marantz® SERVICE BULLETIN		Date: 15-May-2003	Model: SR5200/SR6200/SR7200
		Page: 1/2	REF.NBR: MZ02-033
Circulation:		Subject:	
Application:		Hum noise can be heard from Headphone out.	
x for information customer complaint in case of service mandatory			
See below

marantz® SERVICE BULLETIN		Date: 15-May-2003	Model: SR5200/SR6200/SR7200
		Page: 1/6	REF.NBR: MZ02-032
Circulation:		Application:	
x for information customer complaint in case of service mandatory		See below	
		Subject: Pop noise	
		Int.ref:

marantz® SERVICE BULLETIN		Date: 15-May.-2003	Model: SR5200,SR6200,SR7200
		Page: 1 / 1	REF.NBR: MZ02-027
Circulation:		Application:	
x for information customer complaint in case of service mandatory		See Below	
		Subject: Video synchronization problem.	
		Int.ref:

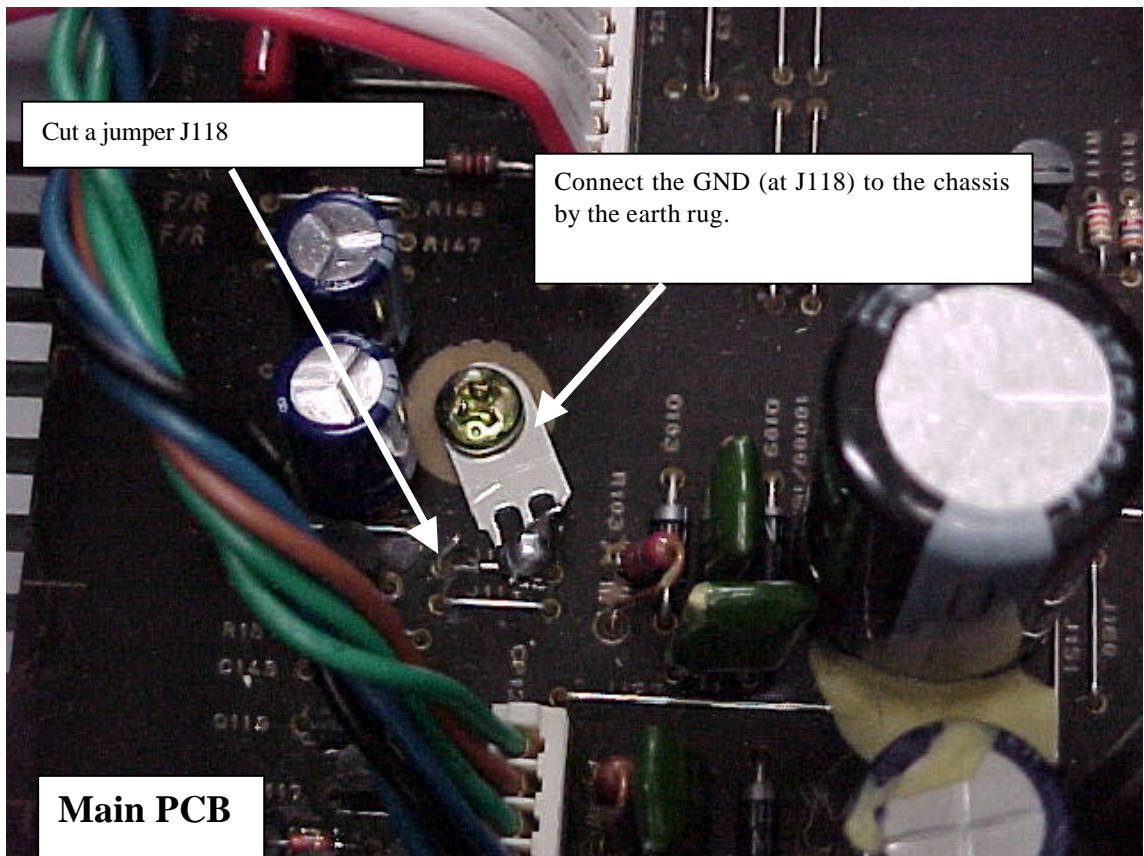
Hum noise can be heard from Headphone out

Caused by ground loop of the headphone out.

Please apply the following solution.

* Version 1 P.C.Board (7020 06076 001-0) : Please apply the modification mentioned below (Page2 to 4).

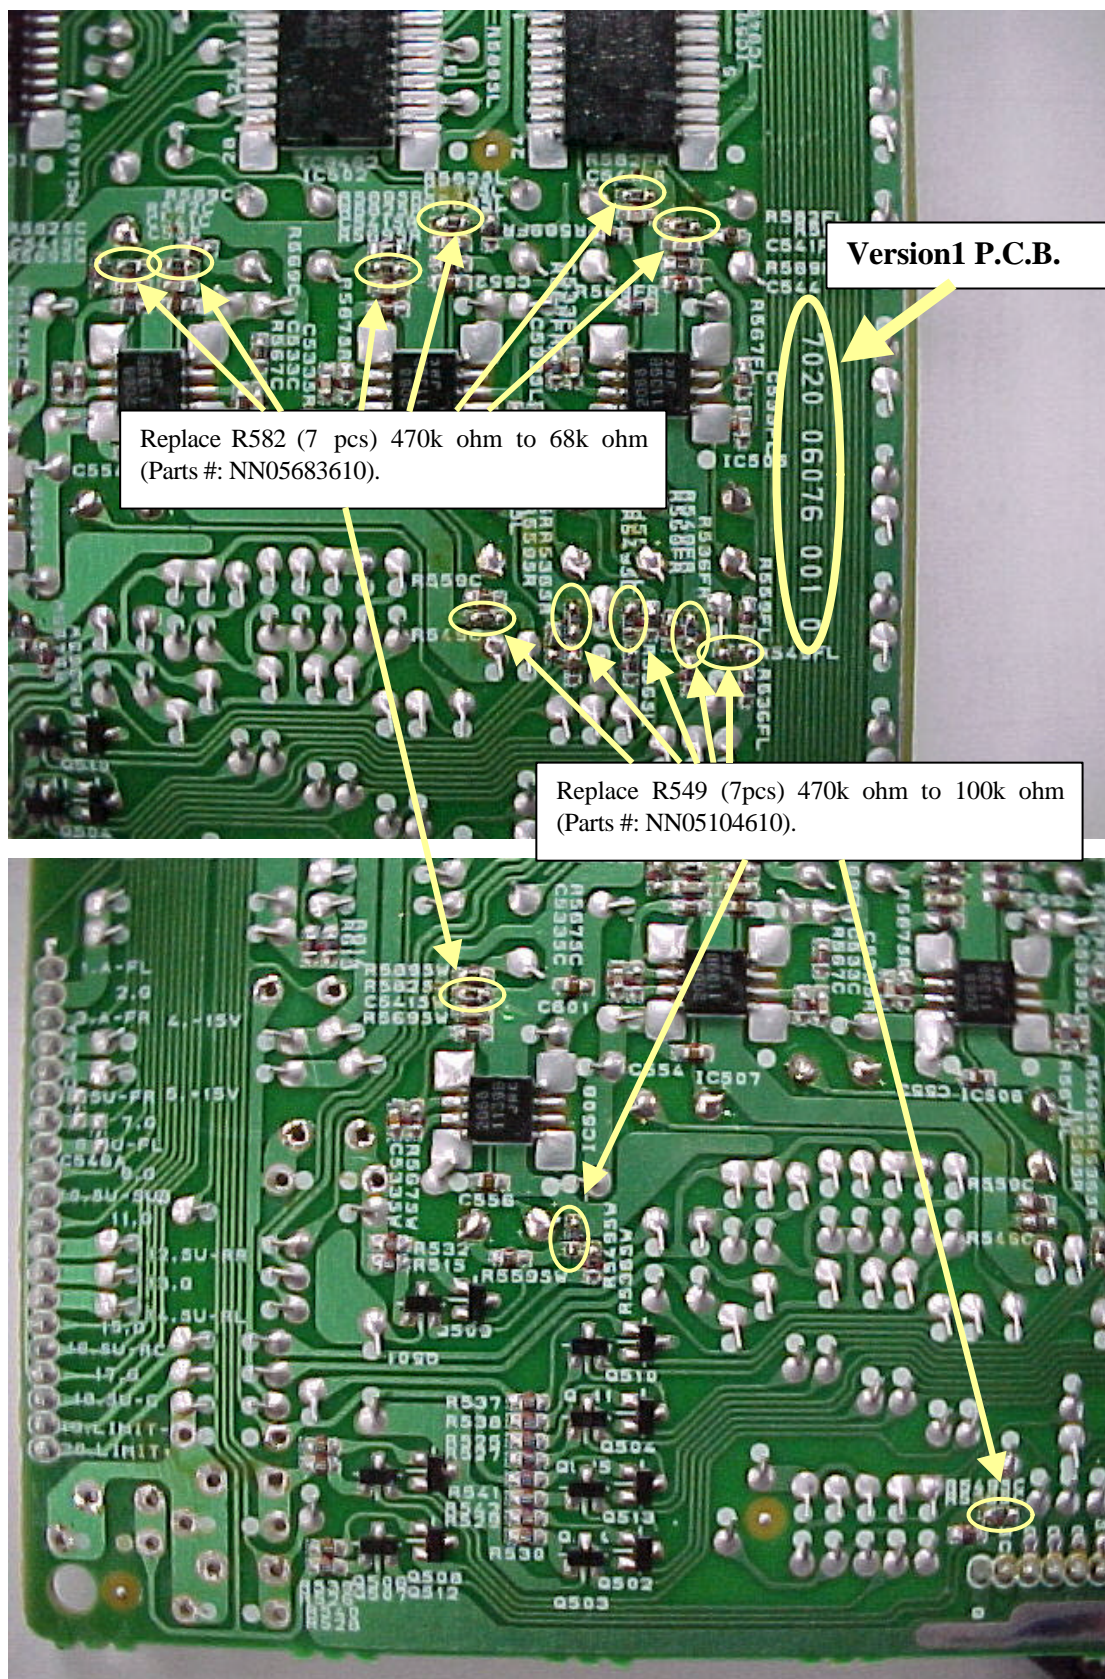
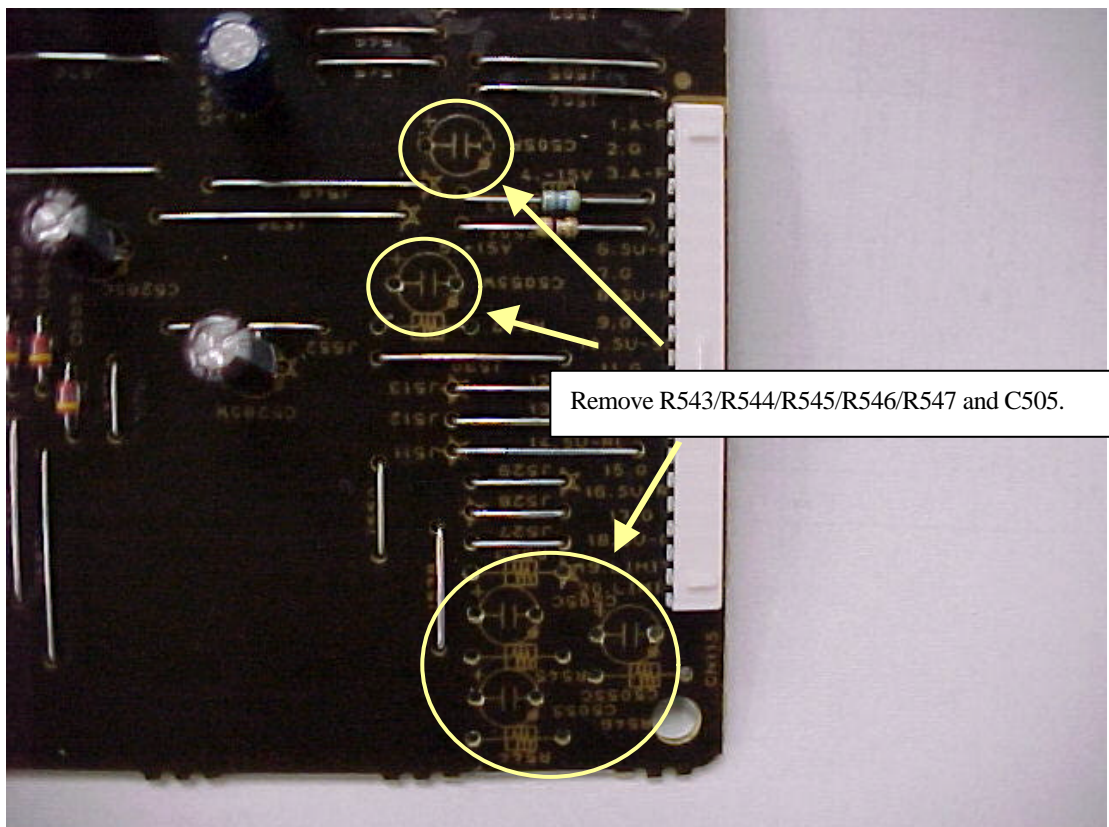
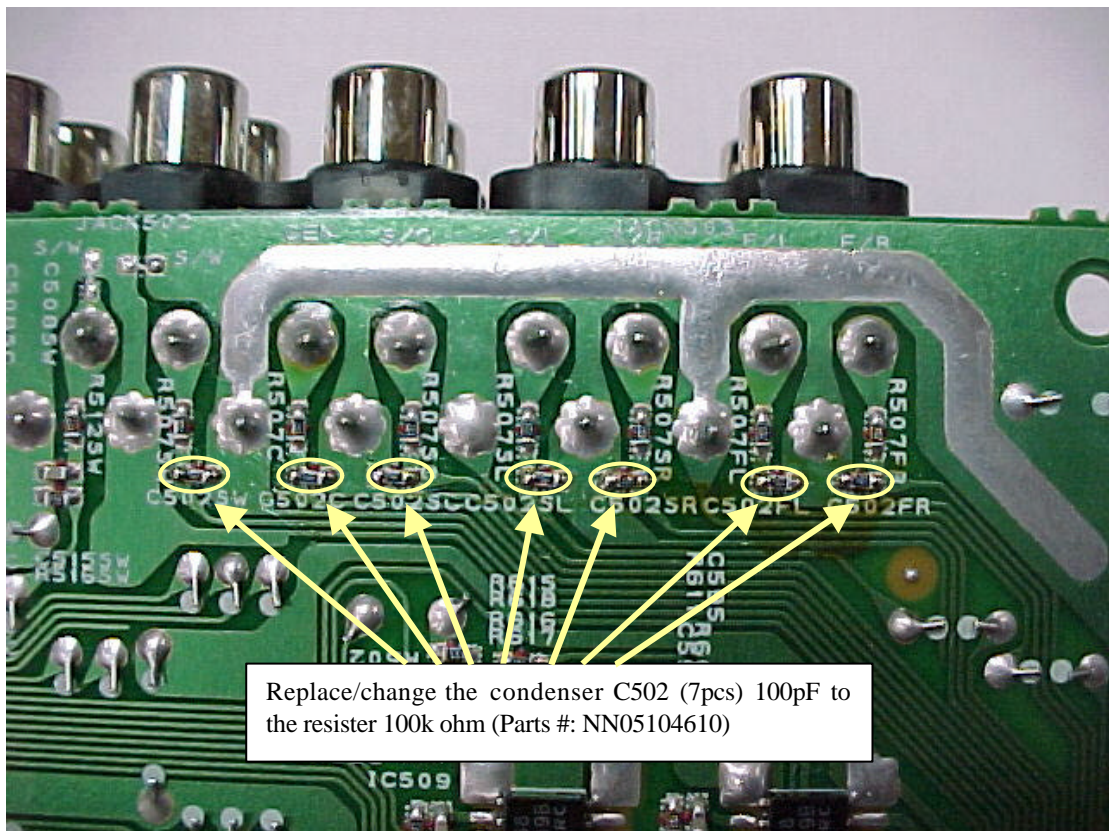
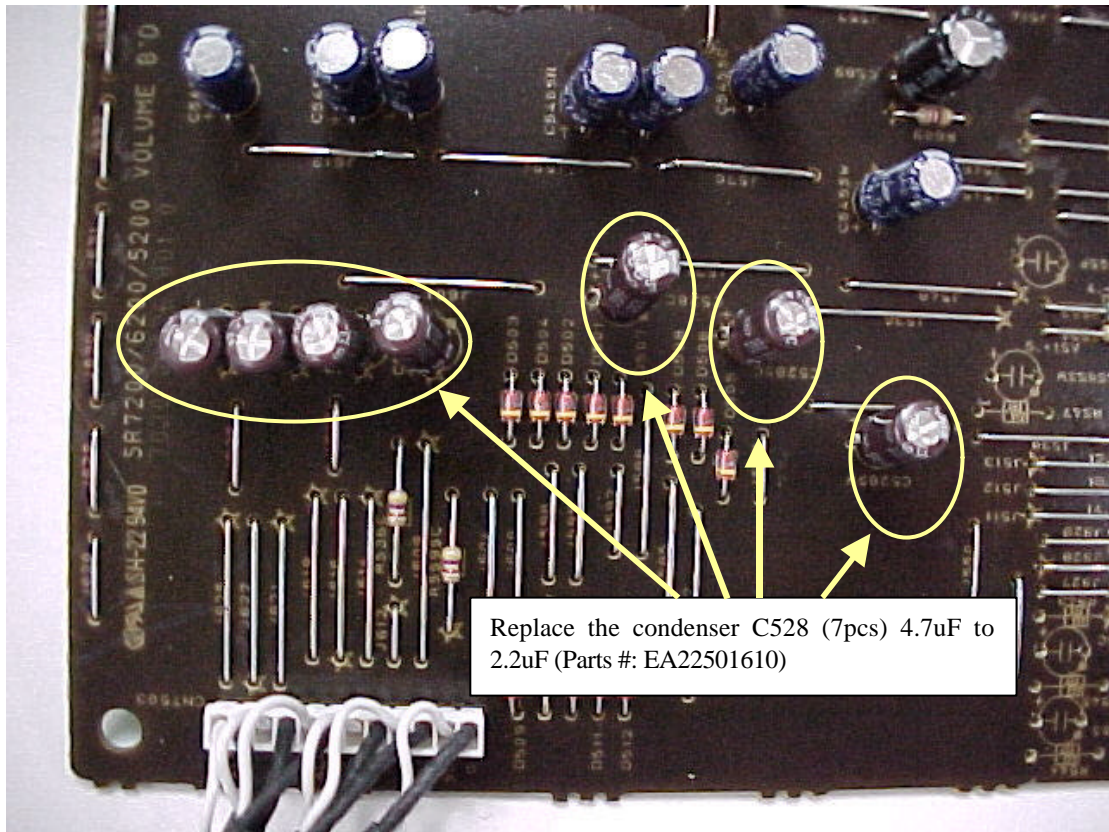
Pop noise appears when stop playing or track skip on CD playback with Digital connection.
Pop noise appears in the condition of the Main volume is changed 74dB to 75dB(Mute) .

* Version 1 P.C.Board (7020 06076 001-0) : Please apply the modification mentioned on Page2 to 4.

Please apply the modifications as mentioned in page 2 to page 6.

PIC.01

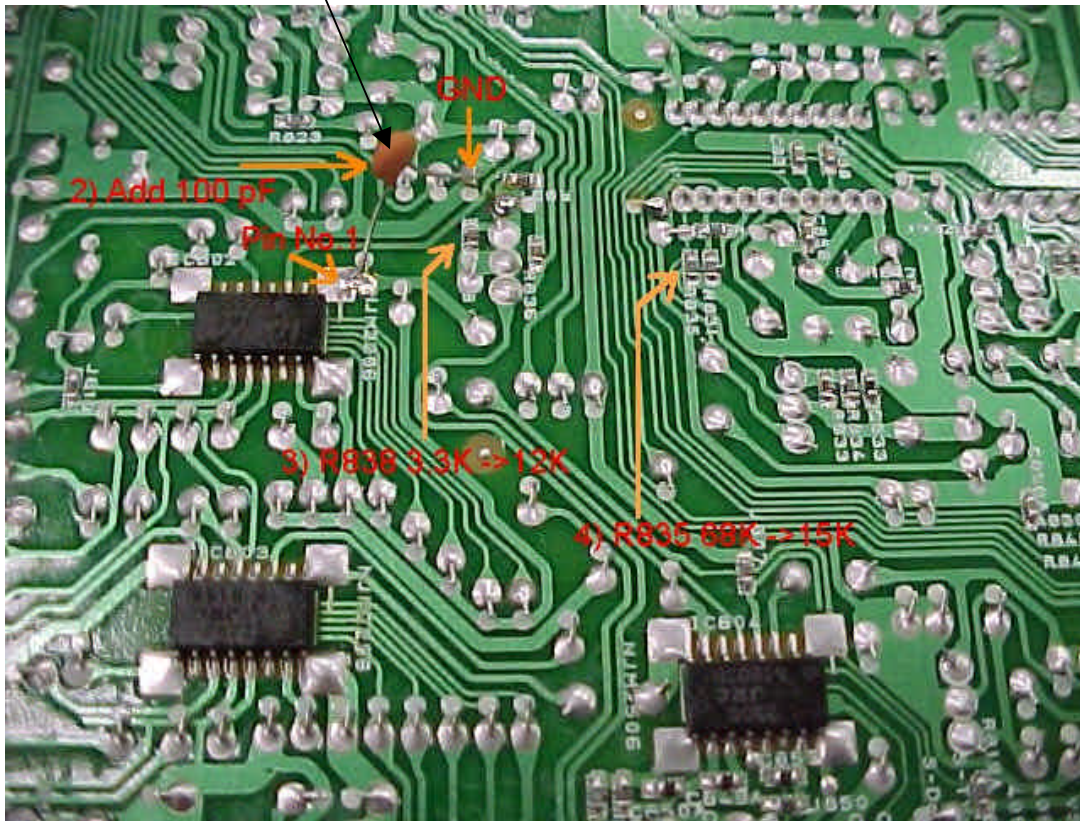
When a output connect with the monitor via the S-VIDEO terminal, noise(stripes) occur at the picture.

The clock from the OSD circuit, it caused interference to VIDEO-AMP circuit.

- 1) The capacitor(C810A 100pF: DK16101300 4822 122 33195) is added between 1P of IC802 and GND(refer to PIC.01).
- 2) The jumper wire(J841) is deleted and a capacitor(C840A 47uF/16V: EA47601620 9965 000 06289) is added to same position (refer to PIC.02).
- 3) The chip resistor(R838) is changed into 12kohm one(NN05123610 4822 051 30123) from the present 3.3kohm one.
- 4) The chip resistor(R835) is changed into 15kohm one(NN05153610 4822 051 30153) from the present 68kohm one.

C810A (100pF: DK16101300
